CLAREMONT BUSINESS PARK 2 FIL. NO. 2

OUTLET STRUCTURE POND 3 DETAILS

SHEET 12 OF 14

LOT 2 - SAND FILTER POND 3
SITE PLAN
SCALE 1"=6'

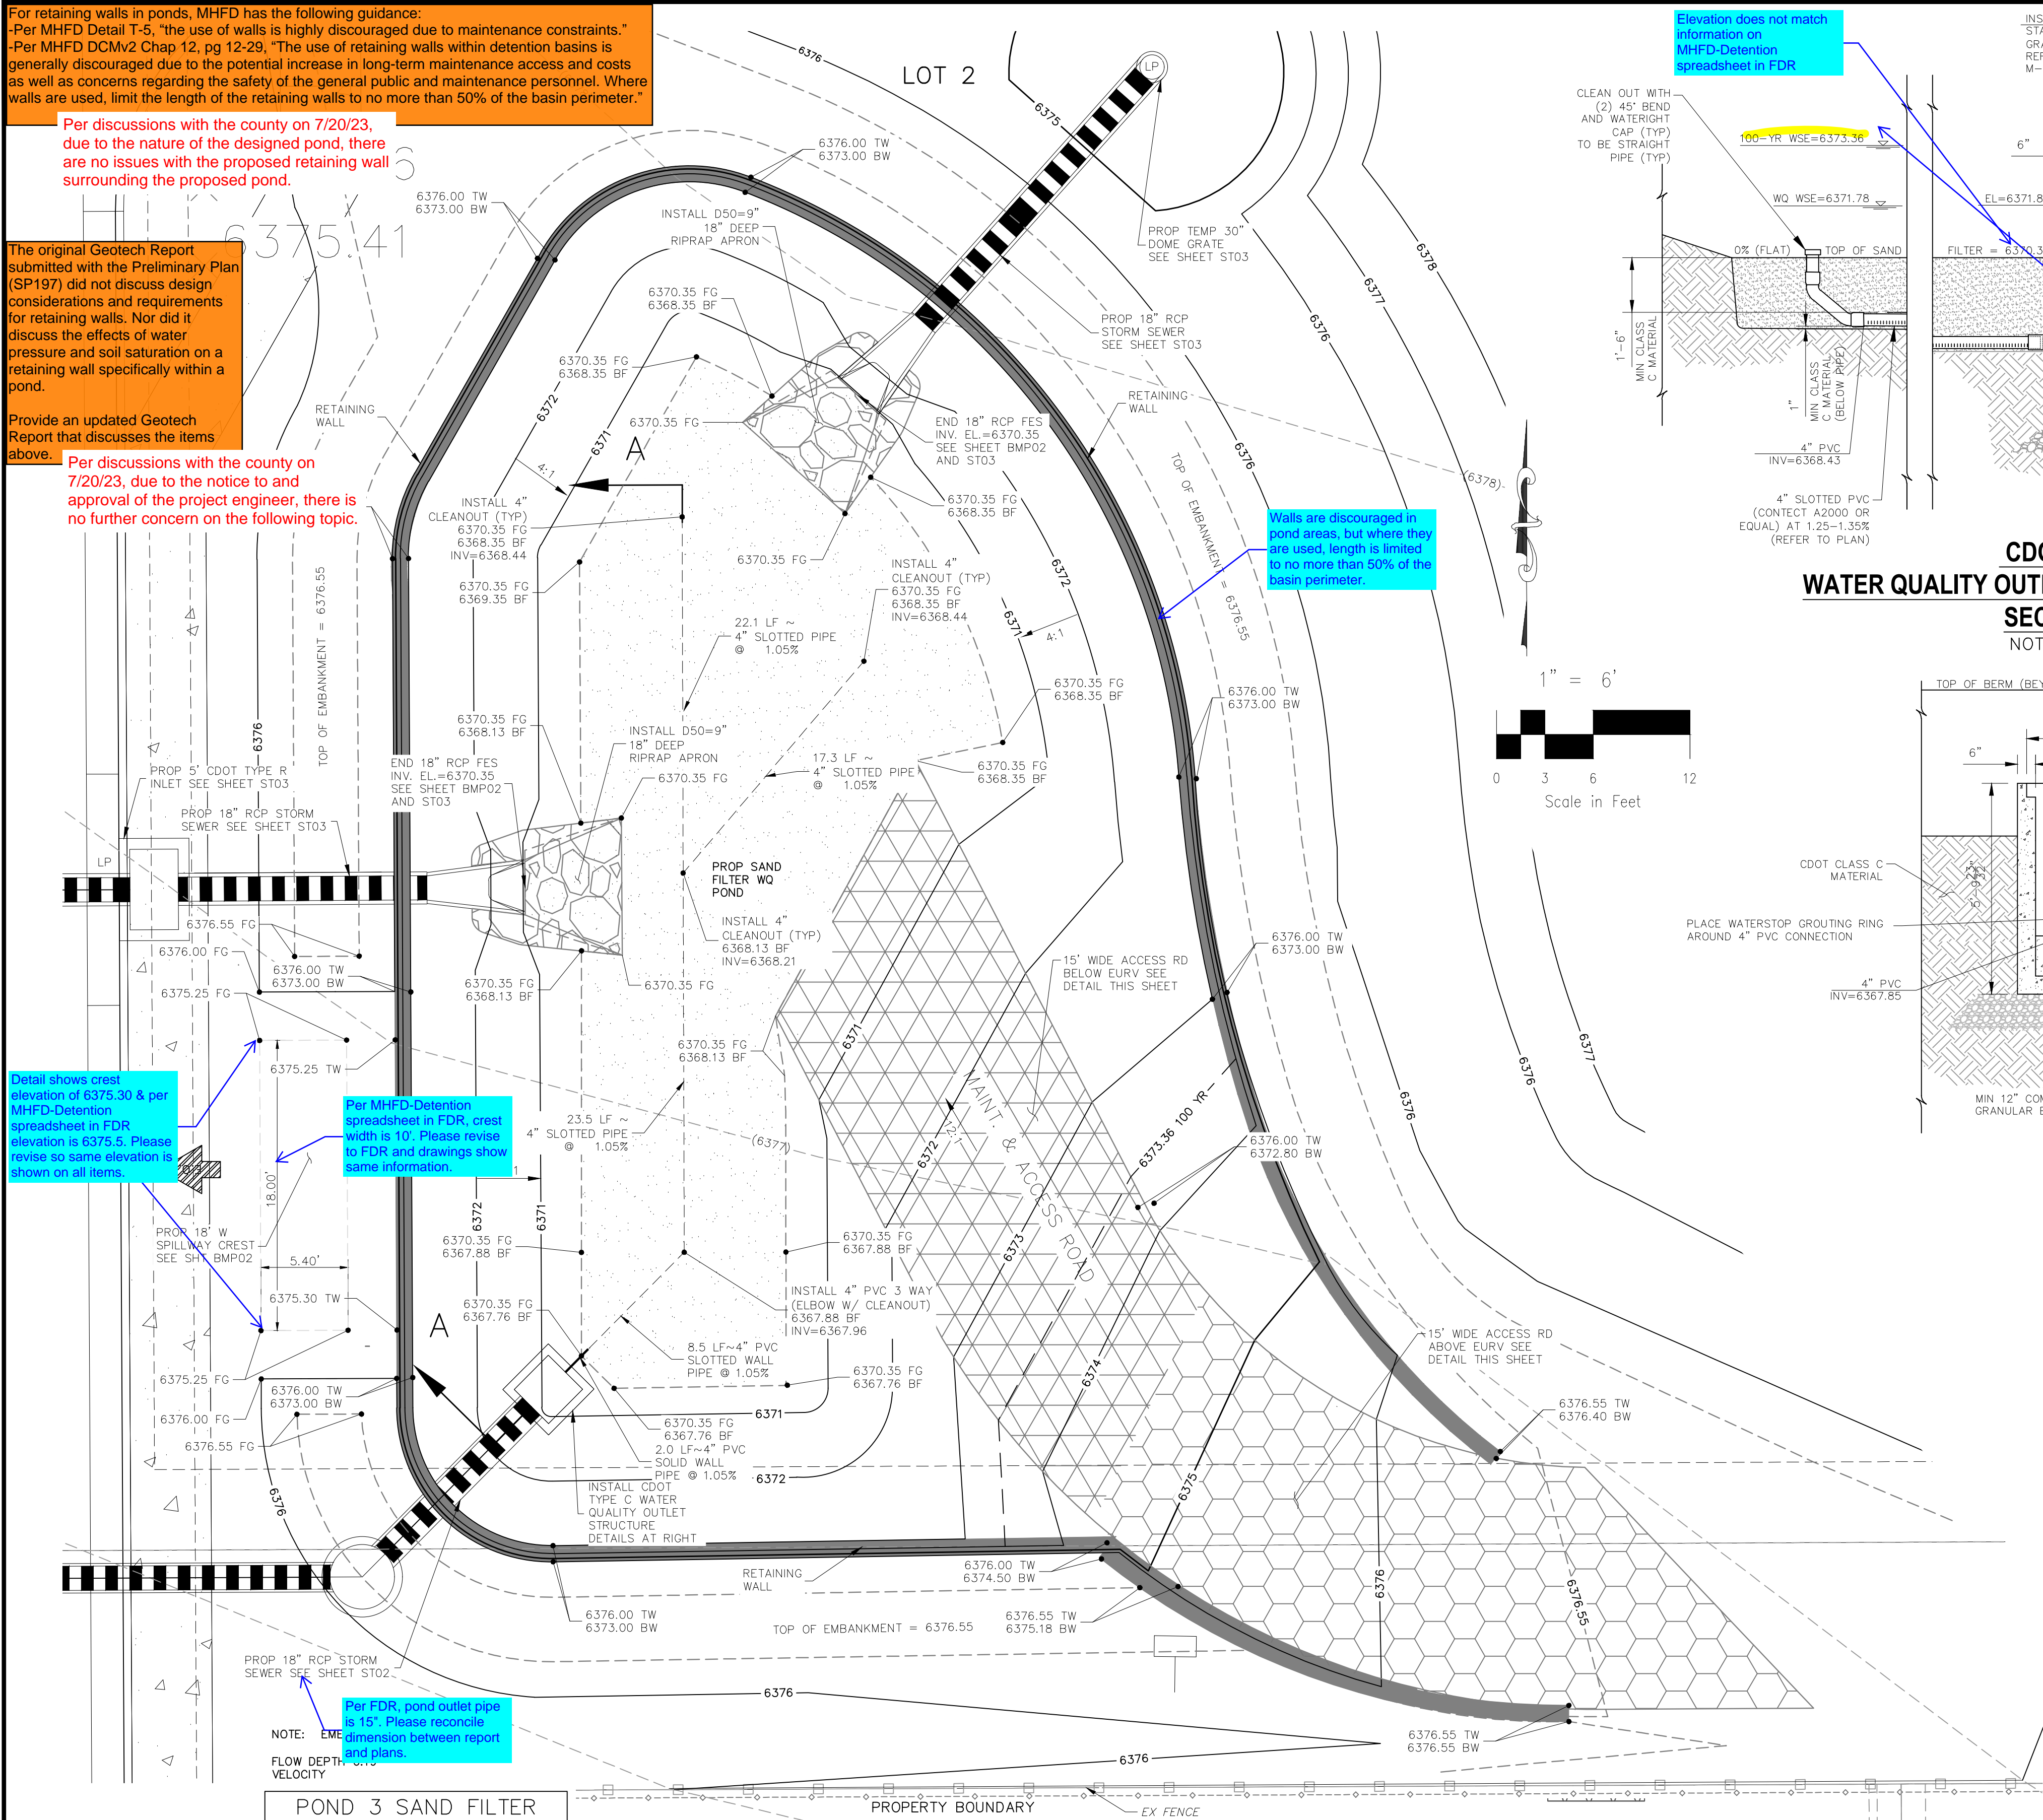
For retaining walls in ponds, MHFD has the following guidance:
-Per MHFD Detail T-5, "the use of walls is highly discouraged due to maintenance constraints."
-Per MHFD DCMv2 Chap 12, pg 12-29, "The use of retaining walls within detention basins is generally discouraged due to the potential increase in long-term maintenance access and costs as well as concerns regarding the safety of the general public and maintenance personnel. Where walls are used, limit the length of the retaining walls to no more than 50% of the basin perimeter."

The original Geotech Report submitted with the Preliminary Plan (SP197) did not discuss design considerations and requirements for retaining walls. Nor did it discuss the effects of water pressure and soil saturation on a retaining wall specifically within a pond.

Provide an updated Geotech Report that discusses the items above.

Walls are discouraged in pond areas, but where they are used, length is limited to no more than 50% of the basin perimeter.

Elevation does not match information on MHFD-Detention spreadsheet in FDR

Elevations do not match. Revise

Per discussions with the county on 7/20/23, due to the nature of the designed pond, there are no issues with the proposed retaining wall surrounding the proposed pond.

CDOT TYPE C
WATER QUALITY OUTLET BOX AND SAND FILTER
SECTION A-A
NOT TO SCALE

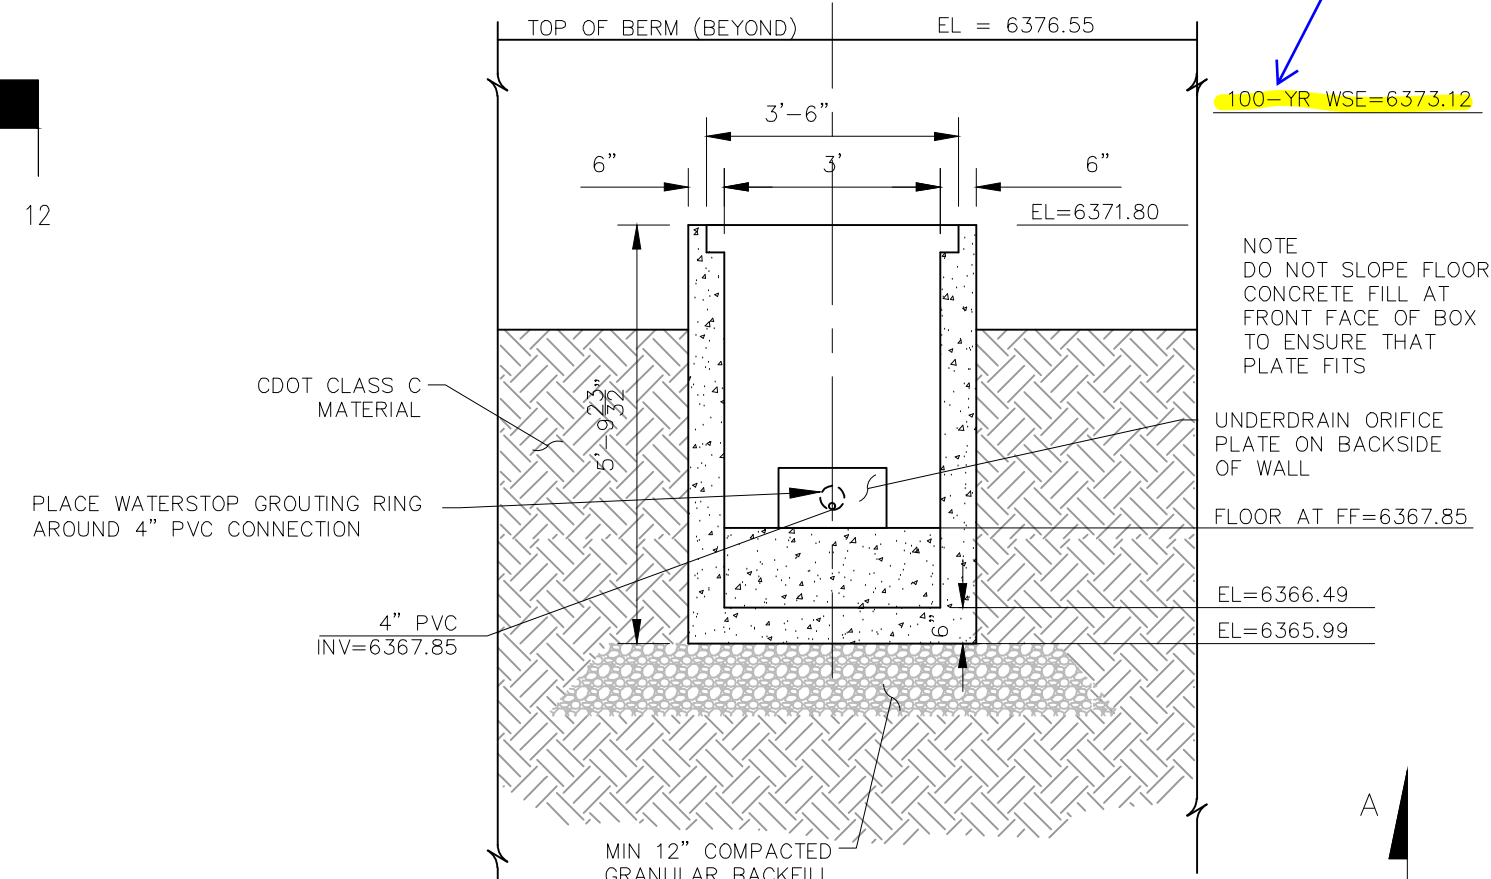
Detail shows crest elevation of 6375.30 & per MHFD-Detention spreadsheet in FDR elevation is 6375.5. Please revise so same elevation is shown on all items.

Per MHFD-Detention spreadsheet in FDR, crest width is 10'. Please revise to FDR and drawings show same information.

Per FDR, pond outlet pipe is 15". Please reconcile dimension between report and plans.

15" pipe per MHFD-Detention spreadsheet in FDR

Per MHFD-Detention spreadsheet, there is no restrictor plate. Please revise so FDR and drawings have same information.

OUTLET BOX
FRONT WALL
NOT TO SCALE

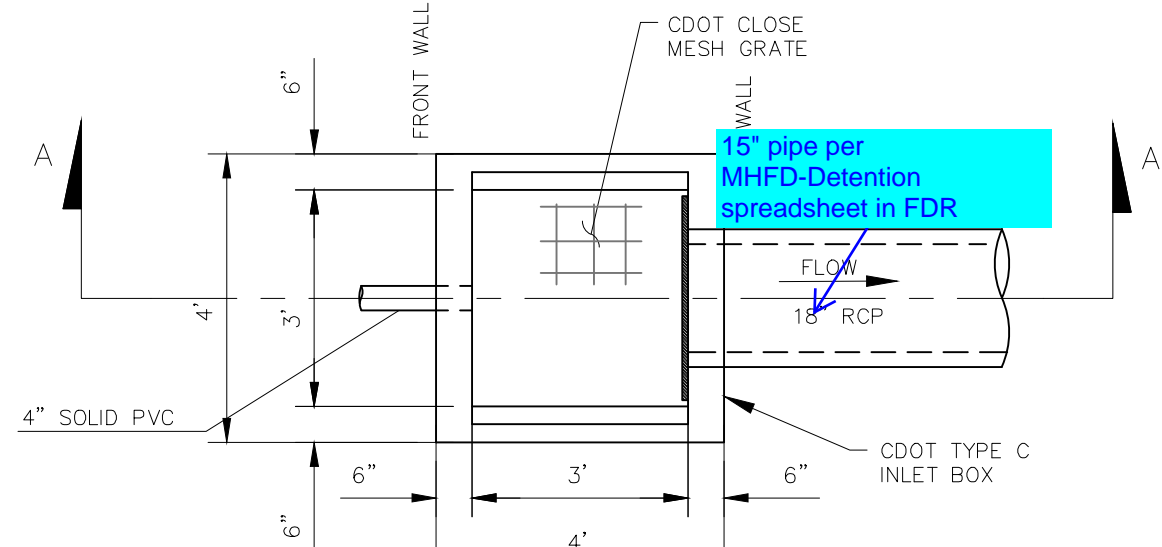
15" pipe per MHFD-Detention spreadsheet in FDR

Per MHFD-Detention spreadsheet, there is no restrictor plate. Please revise so FDR and drawings have same information.
